Virtual Board Meeting
Thursday, January 27, 2022
10:00 a.m.

AGENDA REGULAR SESSION

Resolution 2022-03	Consideration of a Resolution Issuing a Decision on the Variance
	Application Submitted as Part of File No. 20-226 Commercial SG/Sitex
	Group - Site Improvement & Variances Block 229, Lot 5 in the Township
	of Lyndhurst.

Detail of Dwg. P7-A entitled "Truck Turning Exhibit Loading Dock 7," prepared by Matthew J. Seckler, P.E., Stonefield Engineering, dated 3/25/2021, and revised through 07/22/2021.

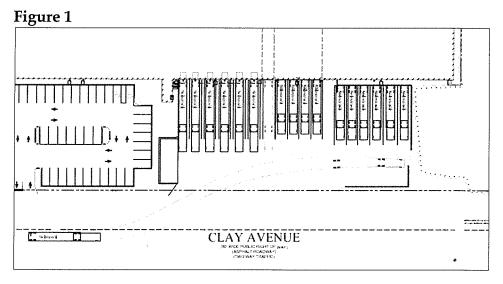
A portion of the expanded pavement in the Clay Avenue front yard adjacent to the site's loading area is intended to better accommodate on-site truck circulation movements for vehicles accessing the site's loading docks, in an effort to minimize movements by trucks within the Clay Avenue ROW as they maneuver into the site's existing and reconfigured loading docks. However, the expanded pavement adjacent to the site's loading area is also intended to accommodate six new trailer parking spaces within the Clay Avenue front yard, which raises public safety concerns and could adversely impact

neighboring properties, due to the intensification of trucks, beyond the existing 11 loading positions, that will be maneuvering on site, potentially blocking access to the 11 loading dock positions and causing additional queuing within the Clay Avenue ROW.

The minimum number of loading spaces required by the regulations is currently provided onsite. District Zoning Regulations do not require a minimum number of trailer parking spaces to be provided.

Accordingly, a recommended condition of this report is that the six proposed trailer parking spaces to the north of the loading doors (see Figure 1) shall be eliminated, with this paved parking area reverting to open space, in order to prevent both the maneuvering of trucks into these spaces from blocking access to the 11 loading dock positions and the queuing and maneuvering of additional trucks within the Clay Avenue ROW, in order to protect the public safety.
